**NEW YORK STATE THRUWAY AUTHORITY
DEPARTMENT OF ENGINEERING**

**AMENDMENT NO. 3
TO**

**CONTRACT TANY 26-23B
D215110
SUPERSTRUCTURE REPLACEMENT OF THE
GARDEN STATE PARKWAY CONNECTOR BRIDGE
OVER THE THRUWAY (I-87/I-287) AT MP 23.53
IN THE NEW YORK DIVISION
OF THE NEW YORK STATE THRUWAY
IN ROCKLAND COUNTY**

Thruway Authority	TITLE OF PROJECT SUPERSTRUCTURE REPLACEMENT GSP CONNECTOR OVER NYS THRUWAY	CONTRACT NUMBER: TANY 26-23B
	LOCATION OF PROJECT BIN 5514049 (MP 23.53)	DATE: JULY 2026
 AZAR DESIGN CO. SHAPING TOMORROW TOGETHER	TITLE OF DRAWING GENERAL PLAN	DRAWING NUMBER: GEN-02

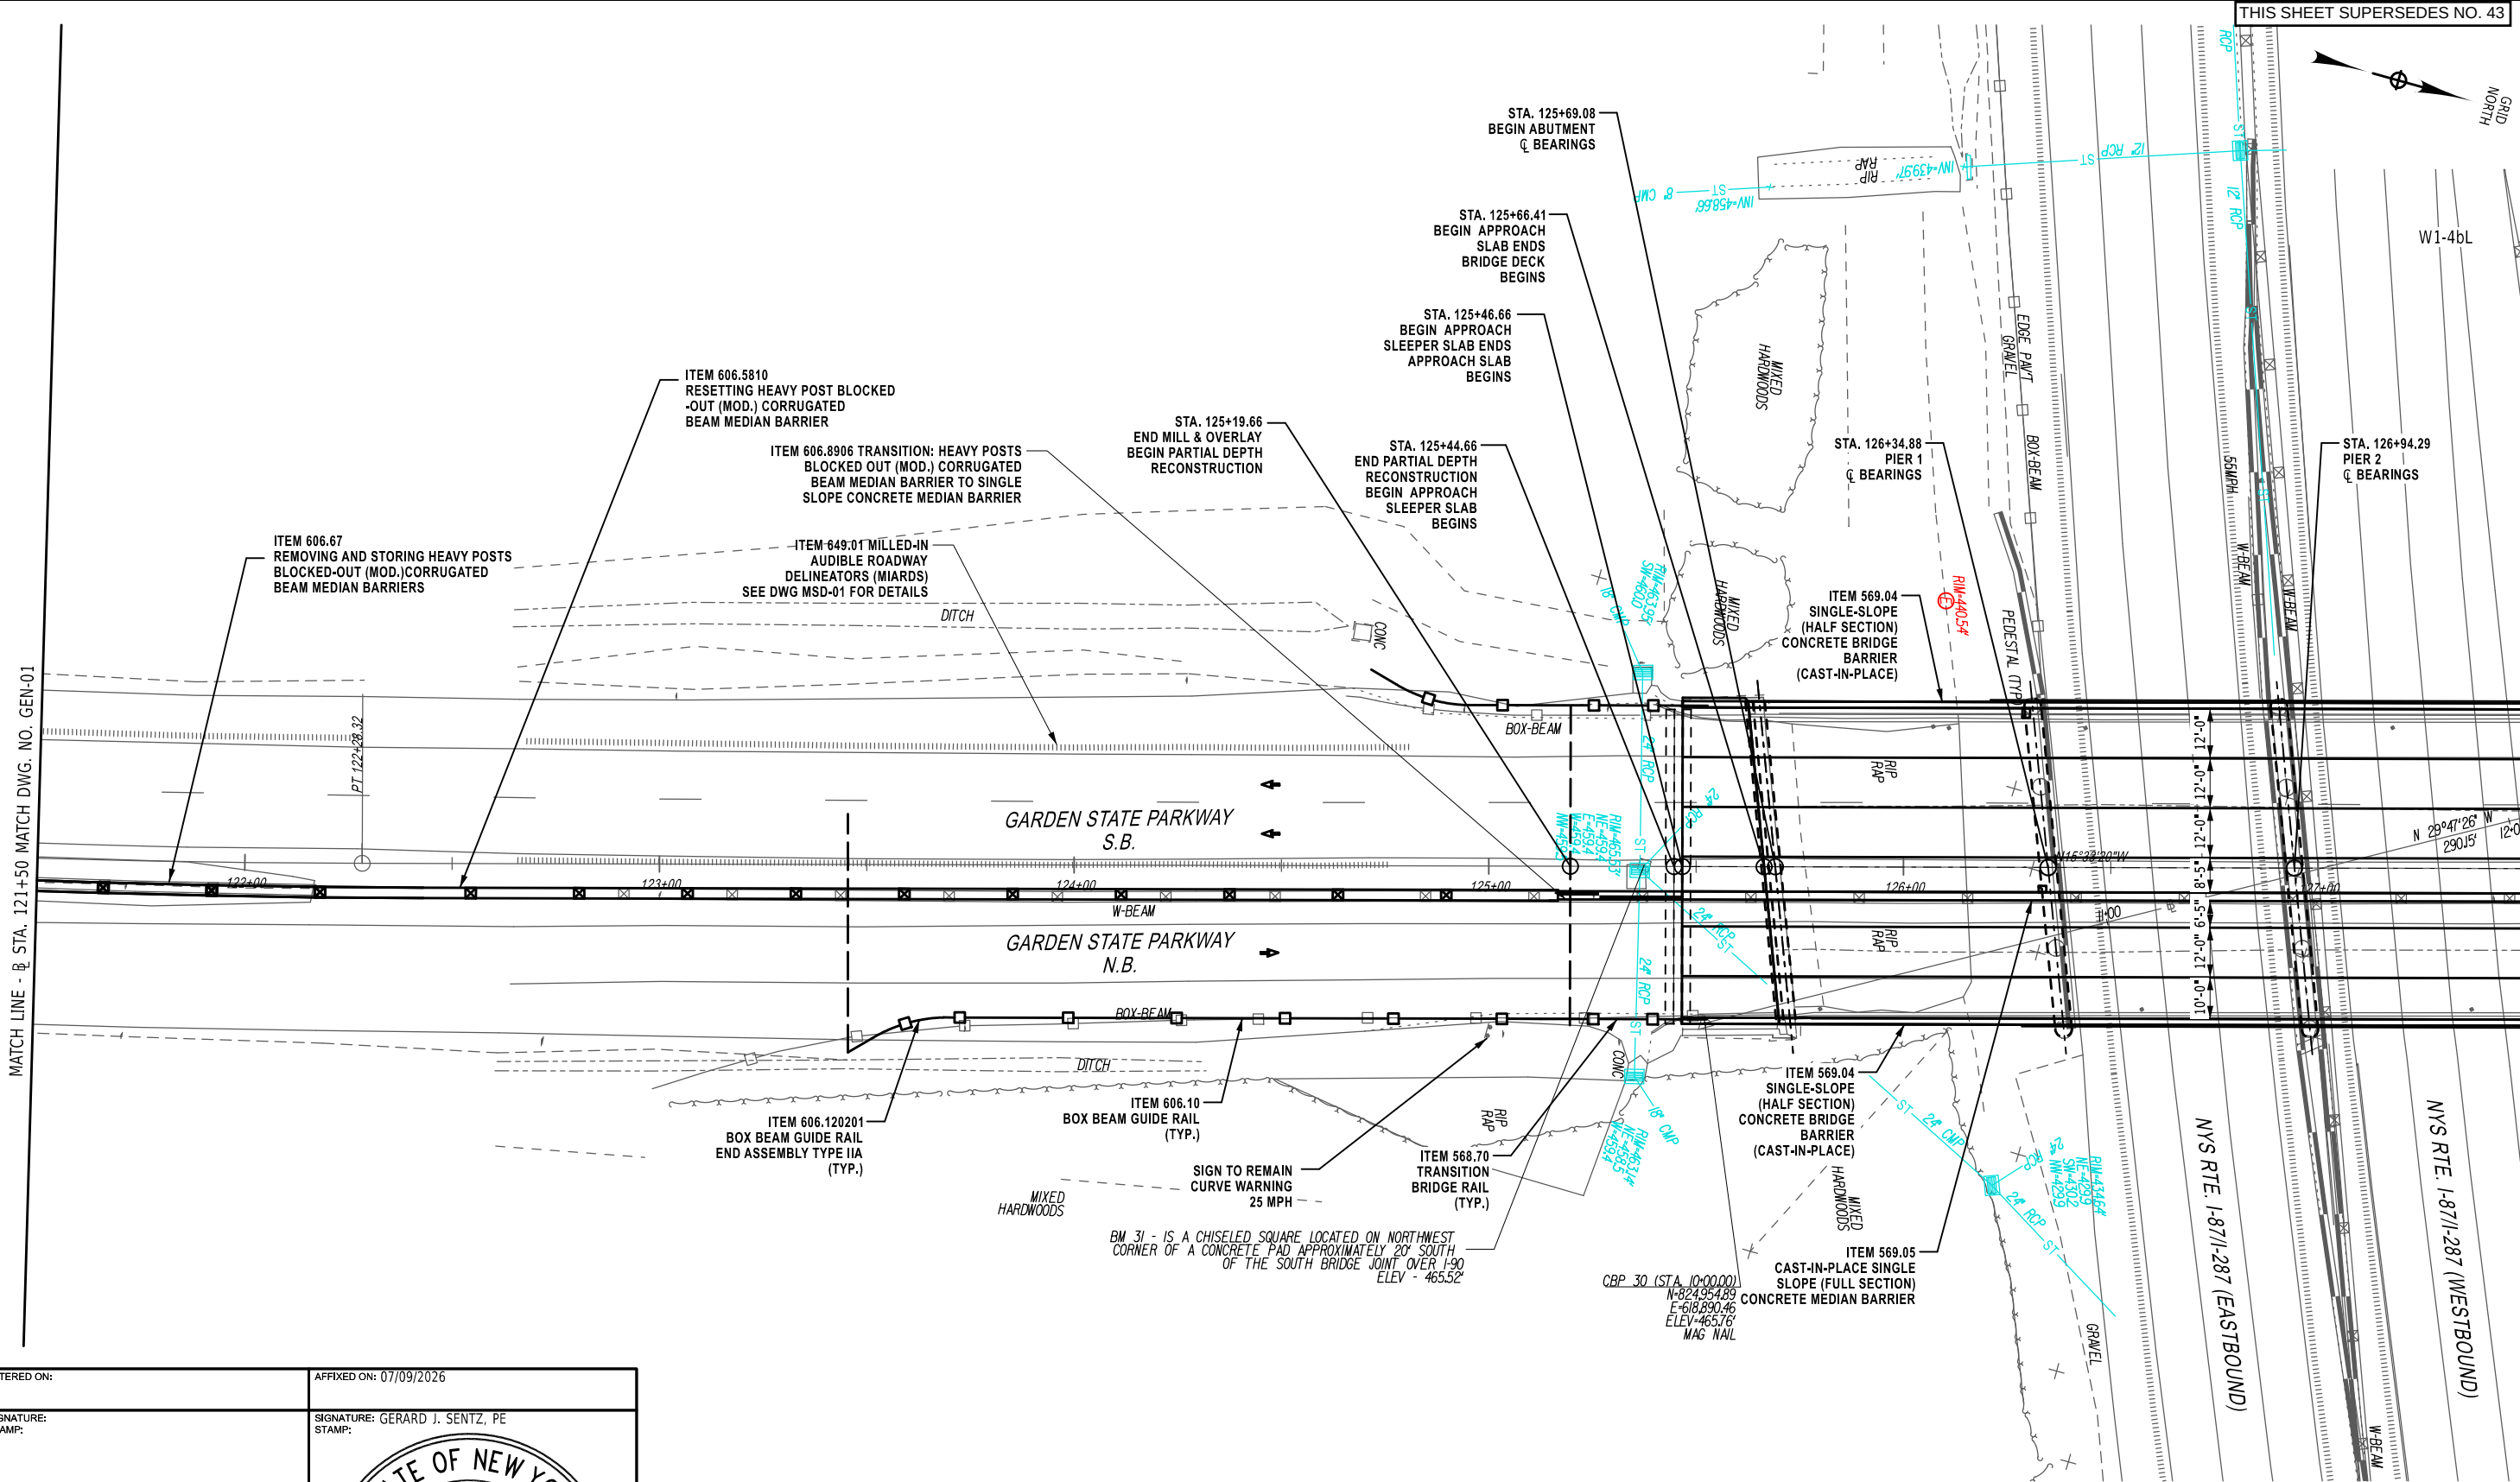
8. **DELETE** Drawing Number GEN-02, Sheet 43 of 118, and **SUBSTITUTE** with the attached Drawing Number GEN-02, Sheet 43A3 of 118. The previous call out for Item 606.3043, Single Slope Concrete Median Barrier (Optional) has been changed to Item 569.05, Cast-In-Place Single Slope (Full Section) Concrete Median Barrier.

DRAWING NUMBER:
ST-12

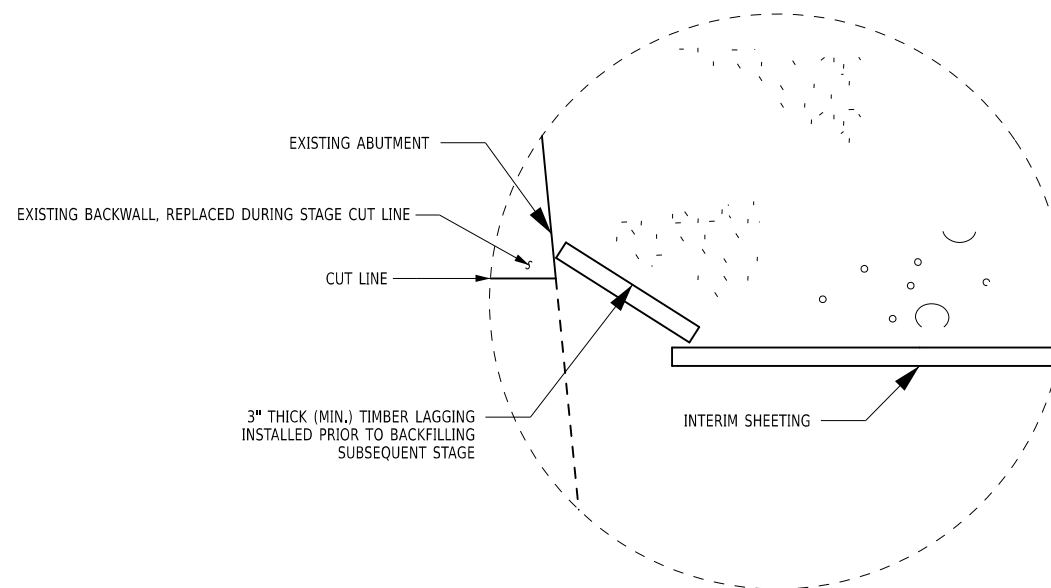
11. **DELETE** Drawing Number ST-12, Sheet 62 of 118, and **SUBSTITUTE** with the attached Drawing Number ST-12, Sheet 62A3 of 118. The previous Notes: 2. regarding the monitoring points at the abutment and footings has been removed. A new Notes: 2 has been added regarding cutting and removing to 2'-0" below the bottom of proposed subgrade, and that any sheeting below is to remain in place.

1. FOR LEGEND, SEE DWG. NO. ST-10.
2. THE INTERIM SHEETING SHALL BE CUT AND REMOVED TO 2'-0" BELOW THE BOTTOM OF PROPOSED SUBGRADE. ANY SHEETING BELOW, SHALL REMAIN IN PLACE.
